CERTIFICATE OF APPROPRIATENESS

Property: 7711 Wynlea Street, Lot 20, Block 56, Section 9, Glenbrook Valley Neighborhood Subdivision. The property includes a historic 1,706 square foot, one-story brick clad single-family residence situated on a 7,150 square foot (65' x 110') interior lot.

Proposal: Alteration- Garage/Siding, and Window:

SOUTH ELEVATION AFTER GARAGE REMOVAL – CURRENT CONDITION

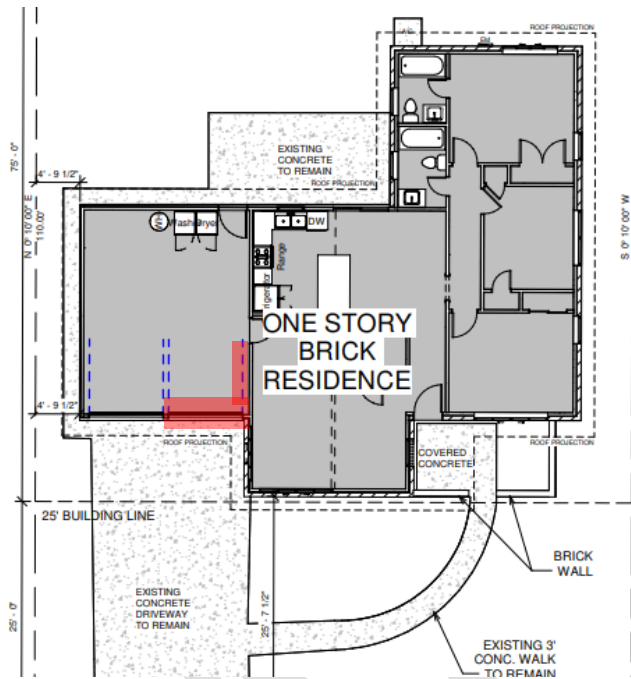
The context area shows two-car garages, one-car garages are not typical in Glenbrook Valley Ranch Style homes. |

A two-car garage is a distinguishing quality or character defining feature of the building. |

The proposed wall and window do not maintain the distinctive stylistic features of the building. |

The material used for the proposed exterior features are not compatible with the mid-century era. |

The replacement of materials are not based on historical evidence. |

Recommendation: Denial of COA – does not satisfy criteria.

Issuance of Certificate of Remediation (COR) to install a new inset garage door similar to existing garage door with vertical column and matching dimension prior to alteration. Applicant to work with staff on final design.
